PROJECT: Grand Canyon and Rosada

CITY OF LAS VEGAS INTER-OFFICE MEMORANDUM				DATE: December 5, 2017
TO: **Land Development Services** Department of Building & Safety				FROM: Albert Sung, P.E. Flood Control Project Engineer Department of Public Works
SUBJECT:	Drainage Study for: **Grand Canyon and Rosada**			**COPIES TO:** GCW Engineers / Surveyors
Cross Streets:	Grand Canyon Drive and Rosada Way			Touchstone Living
File Number:	F:\Depot\DSMemos\DS4924B.doc			Bart Anderson, P.E., DevCo
Parcel Number:	125-31-701-005			CCPW
Zoning Action:	TMP-71297			
FEMA Flood Zone	YES	NO	X	
Proposed Storm Drain	YES	NO	X

RESPONSE TO COMMENTS ON THE TECHNICAL DRAINAGE STUDY FOR GRAND CANYON AND ROSADA

Re: Response to City of Las Vegas Comments on the Technical Drainage Study for Grand Canyon and Rosada

DRAWING
FIG 5
1 OF 1 SHTS

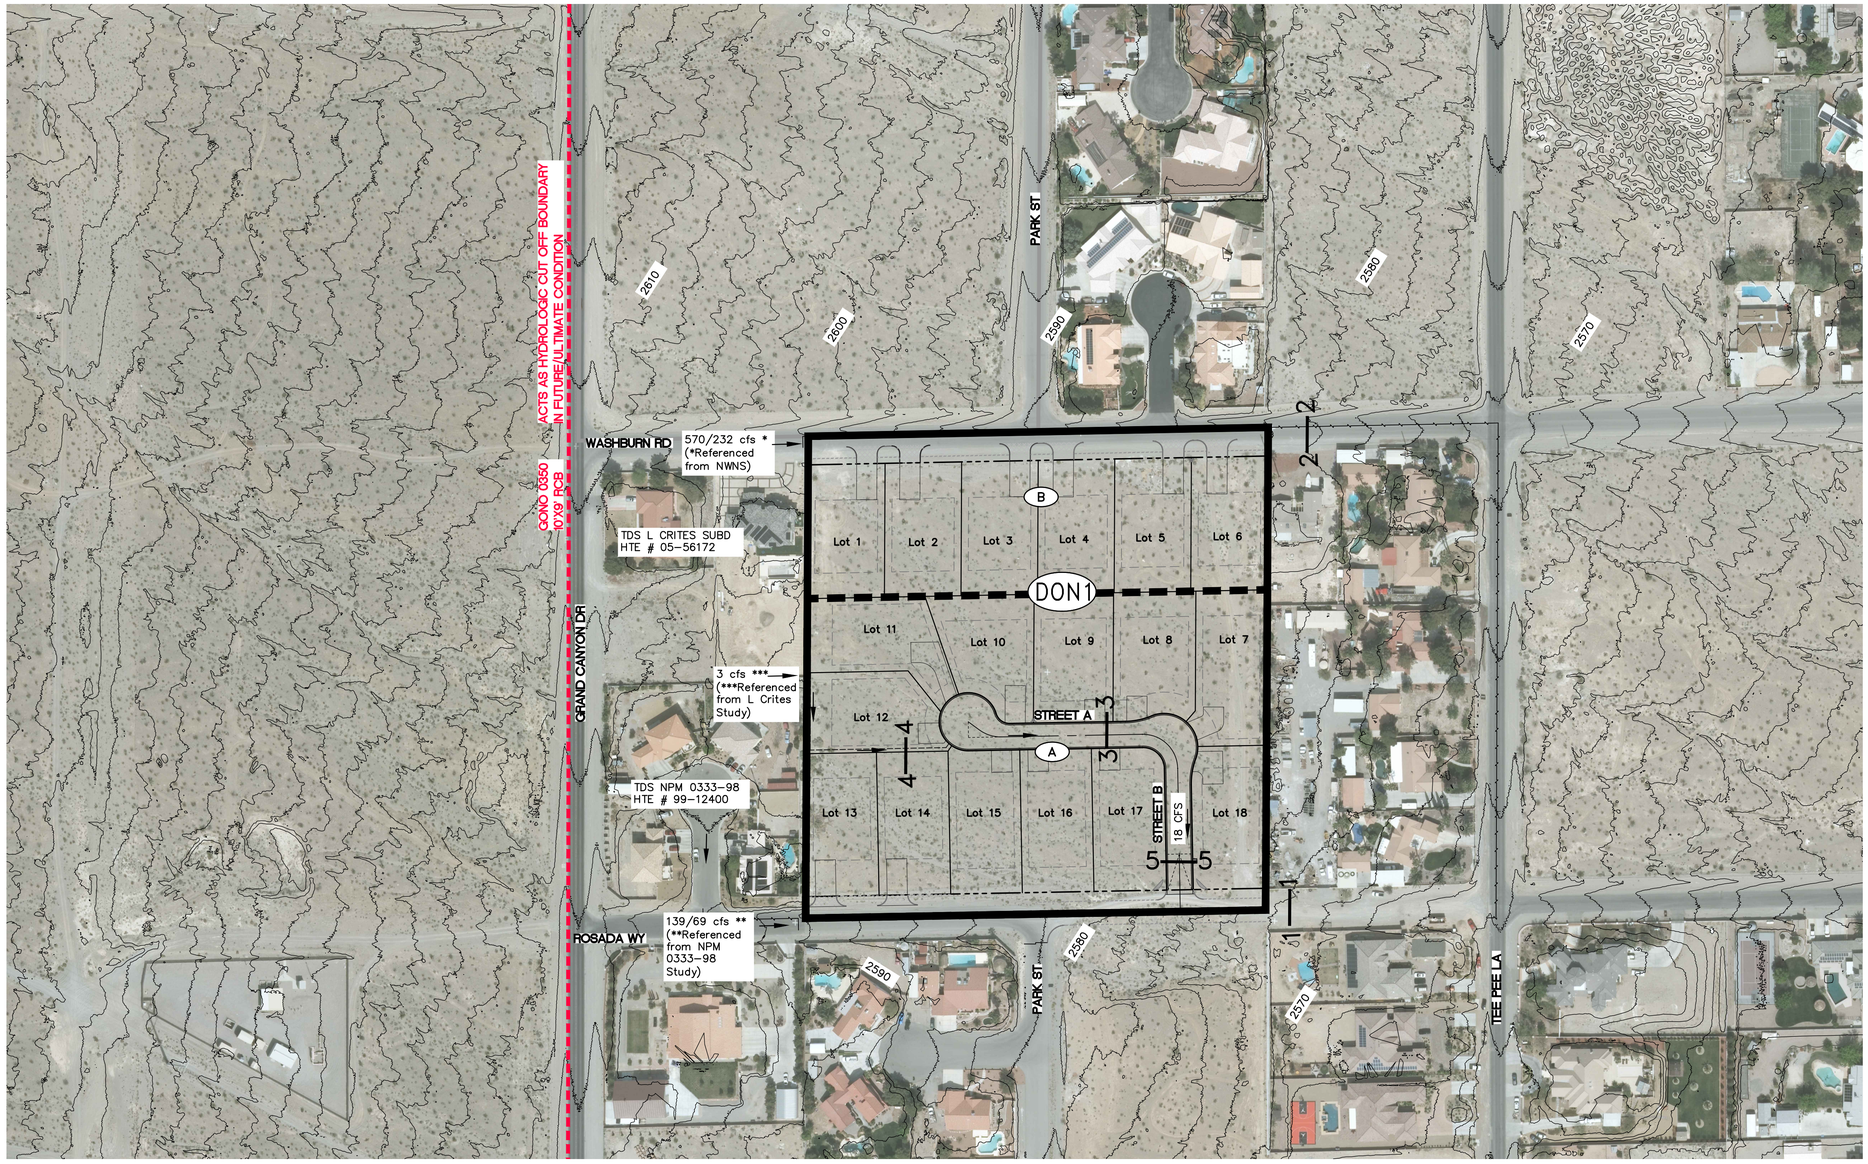
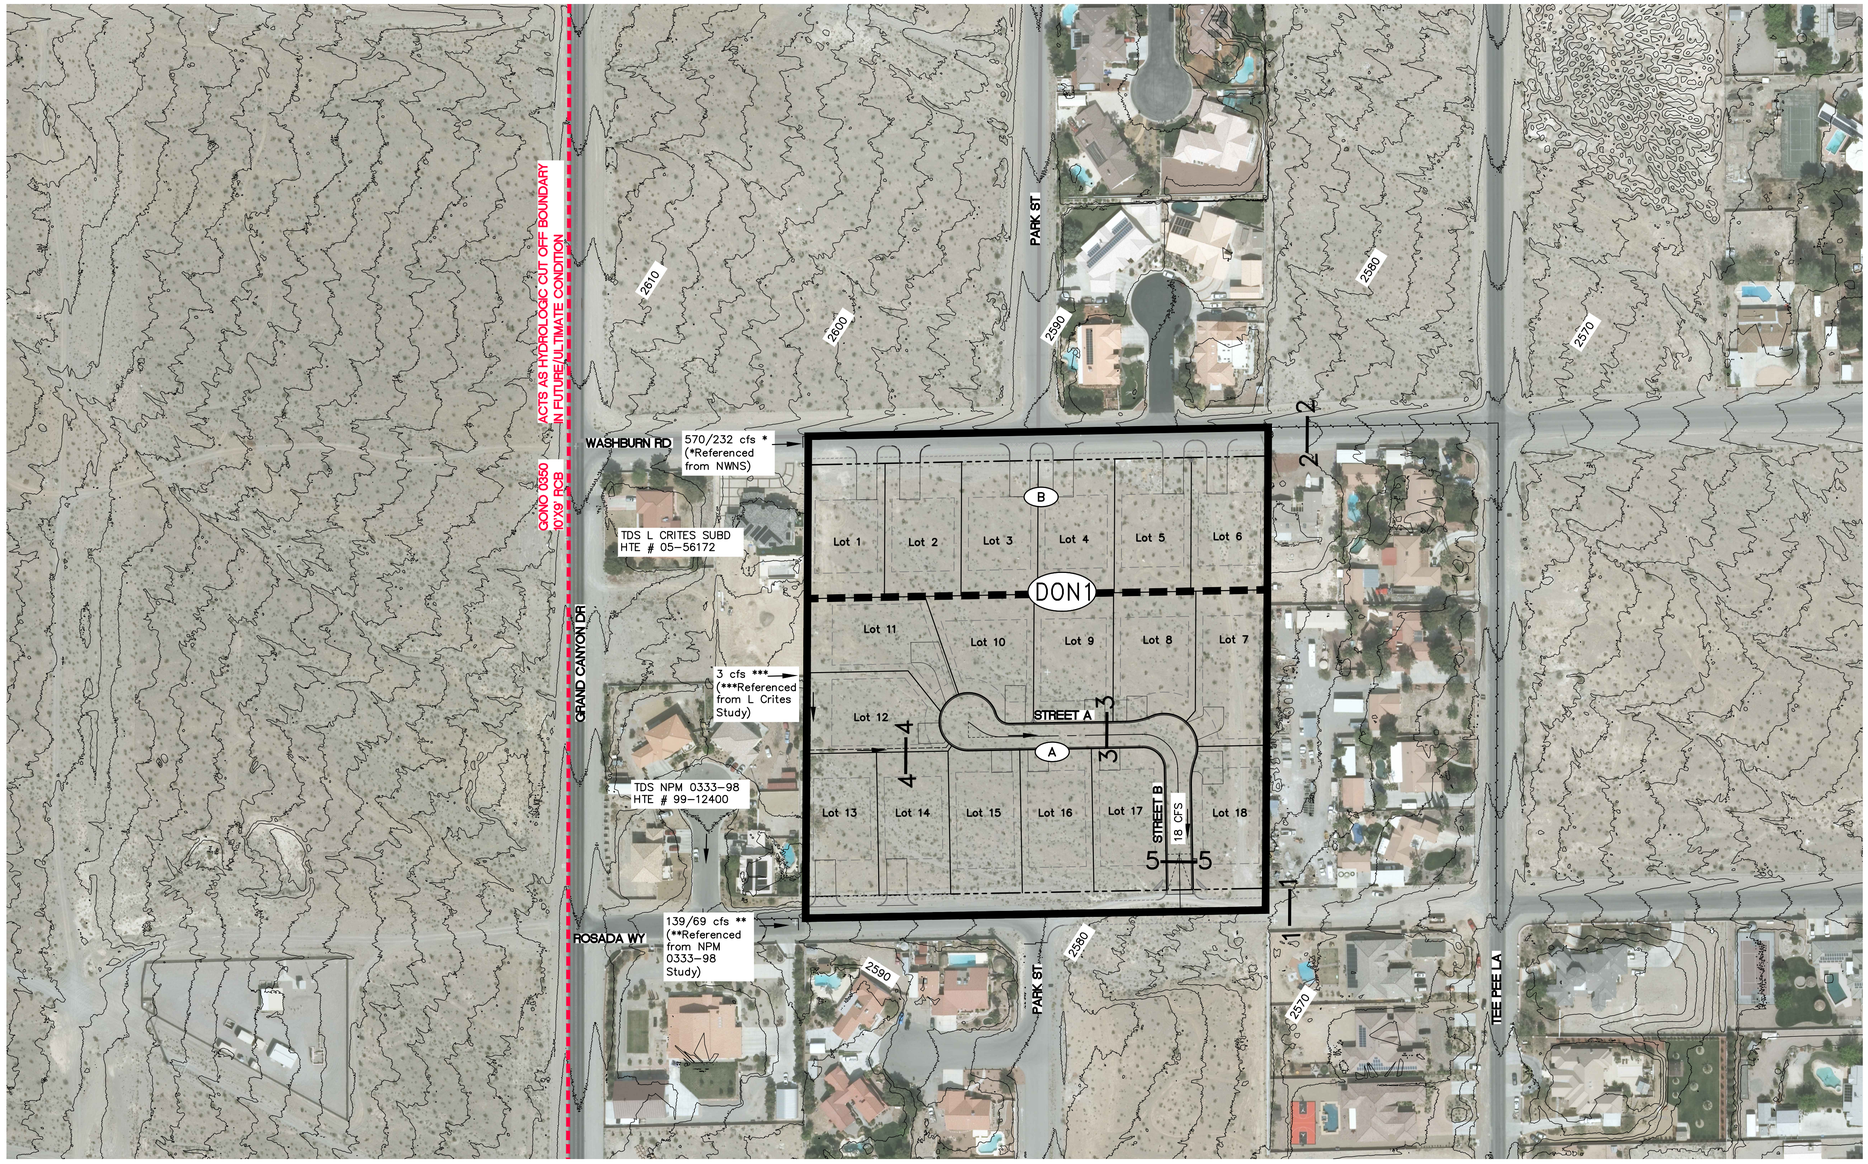
Comment: "6. Per the Northwest neighborhood study the 10-year flow along Washburn should be 232 cfs, not 234 as shown on Fig 6."

Response: The referenced flow rate on Figure 6 as well as Figure 5 have been corrected.

Worksheet for 4-4: Drainage Easement

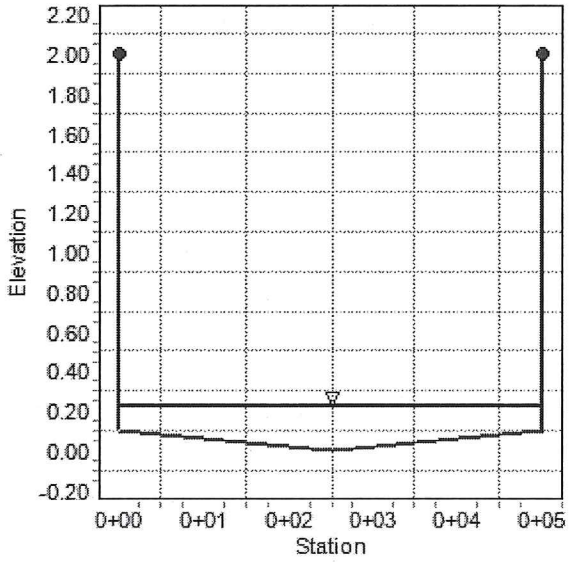
Comment: "10. **Sheet D2:** the drainage easement shown in Details A, E, F and G must be concrete lined. Revise in the next submittal."

Response: The drainage easement has been revised to be concrete lined. Note that the previous calculation has also been corrected to show the drainage easement as 5-feet instead of 10-feet. The normal depth calculation for the drainage easement and the table on Figure 6 have been revised and are included in the appendix.

DRAWING
G1
5 OF 22 SHTS

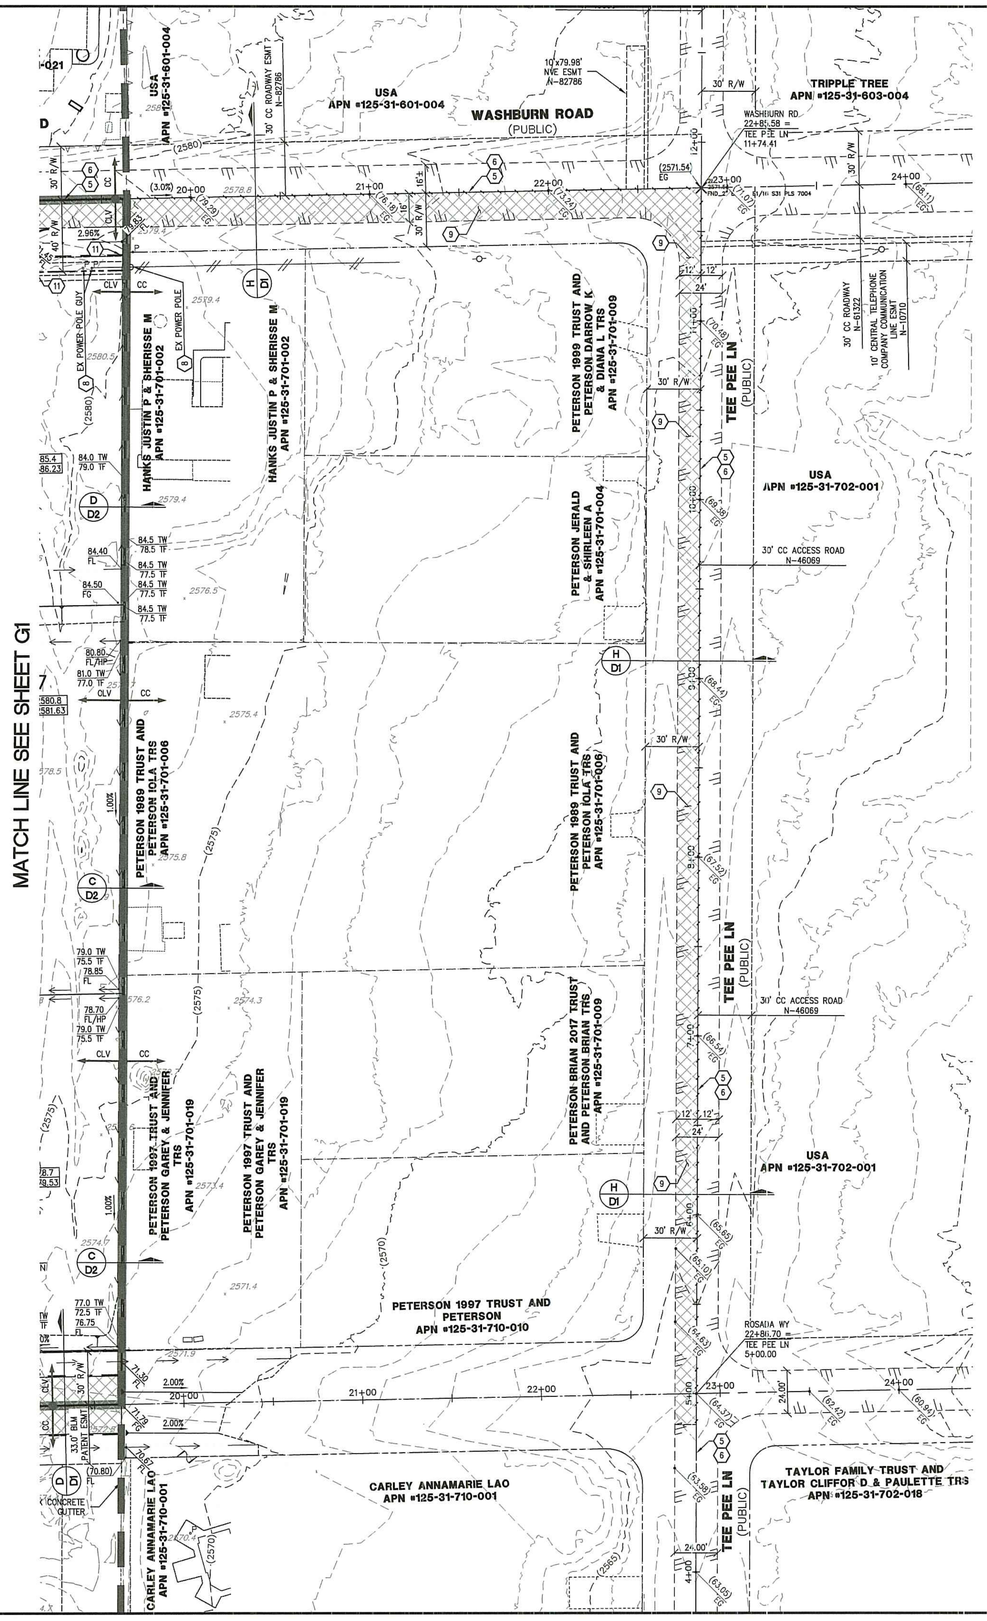
Comment: "8. **Sheet G1:** The drainage easement between Lots 12, 13 and 14 should be designated as a public drainage easement to be privately maintained

and to be dedicated as a common lot. Label on the grading plans and record as such in the final map."

Comment: "9. **Sheet G1:** Callout K/D2, located between Lots 11 and 12, does not exist, please revise."

Comment: "13. The engineer must provide a table on the grading plans that shows a quantity estimate of all drainage improvements within Public Drainage Easements. All drainage improvements within Public Drainage Easements must be bonded and inspected."

Response: The subject drainage easement has been revised to be a public drainage easement to be privately maintained. The normal depth calculation for the easement has been updated to accurately reflect the 5-foot width and the new mannings value for the concrete lining. Per the memo included in the appendix the drainage easement is not required to be dedicated as a common lot.

Response: The K/D2 callout was incorrect. The plans have been revised to show the correct K/D1 callout.

Response: Noted. A table showing the quantity estimate has been added to sheet G1.

H DRIVEWAY ALONG WASHBURN ROAD (PUBLIC)
NTS

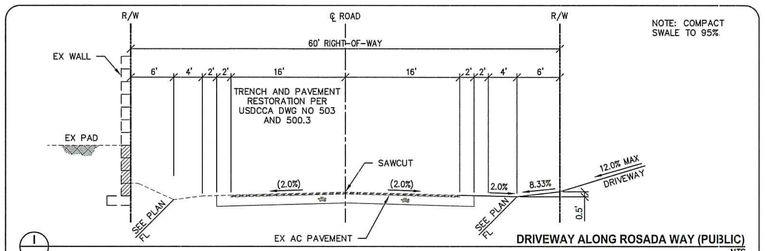
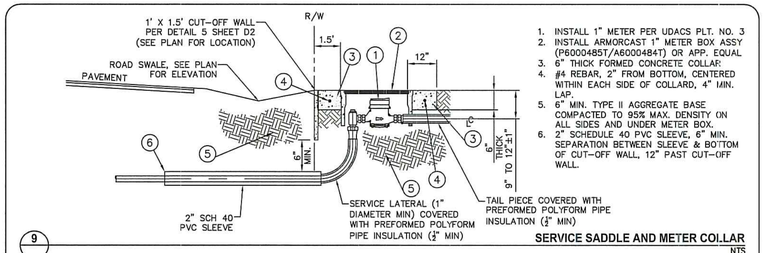
Comment: "5. Provide driveway elevations at the cutoff walls and a cross section detail of the driveways along Washburn Road and Rosada Way."

Response: Driveway elevations at the cutoff walls and cross section details of the driveways along Washburn and Rosada have been provided.
